HISTORICAL ANALYSIS AND DESIGN REVIEW:

Property Address: 40 East Bridge Street (40 N Blacksmith Lane on the Auditor's website.)
Dublin, Ohio 43017

Request: Remodel and addition to the existing structure.

Views from Riverview

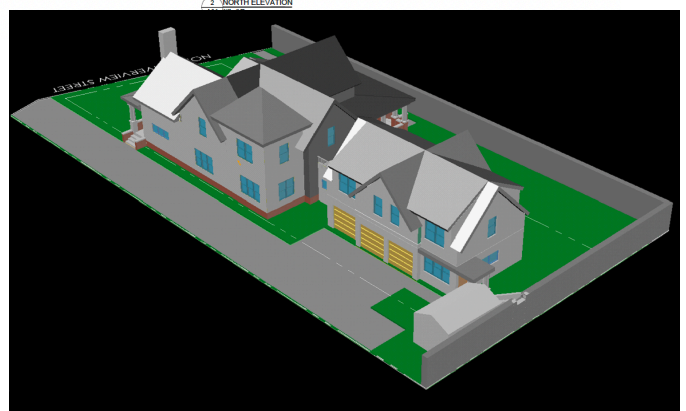
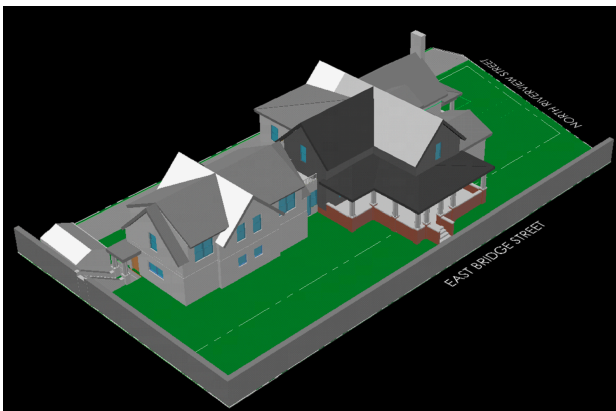
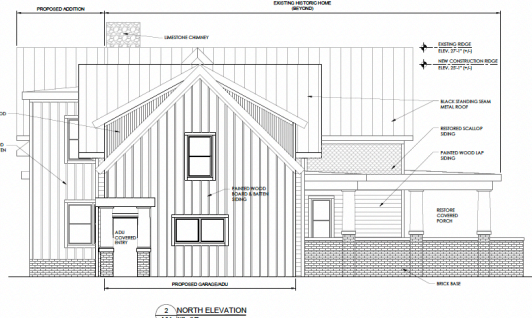
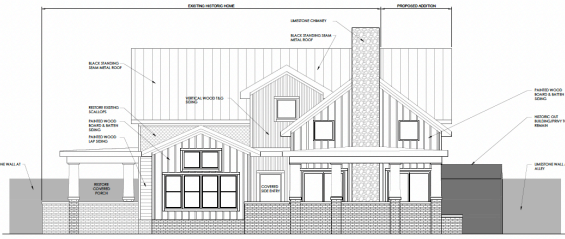
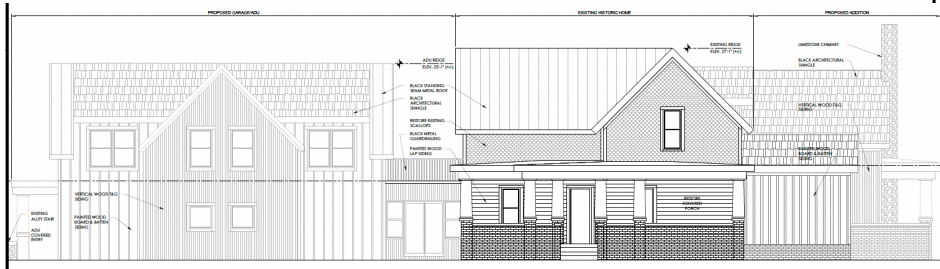
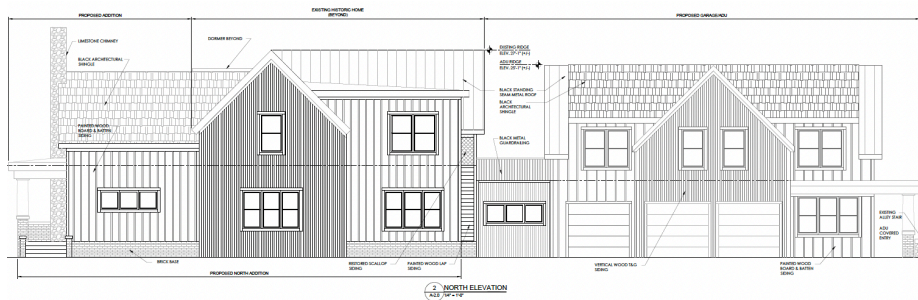
This conceptual design proposal shows both an addition on the Riverview facade and a rear addition and attached garage/carriage house facing Blacksmith Lane. This proposal significantly increases the mass of the home. Due to this location of this particular site an attached addition seems appropriate and will bracket the string of original homes along Riverview. However, the addition on the back should be much more deferential and smaller than the front.

The detailed elevations that have been submitted do not show the additions as secondary and deferential to the original structure. The front addition could be successful even though it hides the original front because it ties in to the existing wrap around porch and uses the same elements, such as the columns, creating a nice dialogue with the original porch. However, the rear addition is too big and competes directly with the primary structure where it should compliment the original and be smaller.

Although the increased lot coverage for this home is within the allowable range, the overall structure will be significantly larger than the existing home and the addition in the conceptual modeling looks too large. Due to the unique siting of this home next to Bridge Street this lot may be the one lot in the row where an attached, elongated addition is appropriate and will bracket the end of the row of residential structures. However, the carriage house/garage addition should be more subordinate to the primary structure. This could be done by lowering the ridge height, decreasing the footprint, reducing the number of garages, or any other design solution that would make the back more subordinate to the front. The final detailing will be essential to its success. The addition to the front is interesting and creative and, again, will be dependent on the details as the design develops. Minimizing the use of different materials and shingle profiles will help to make a cohesive and elegant single family home. The roof lines appear to be complicated and will need to be flushed out in the design development.
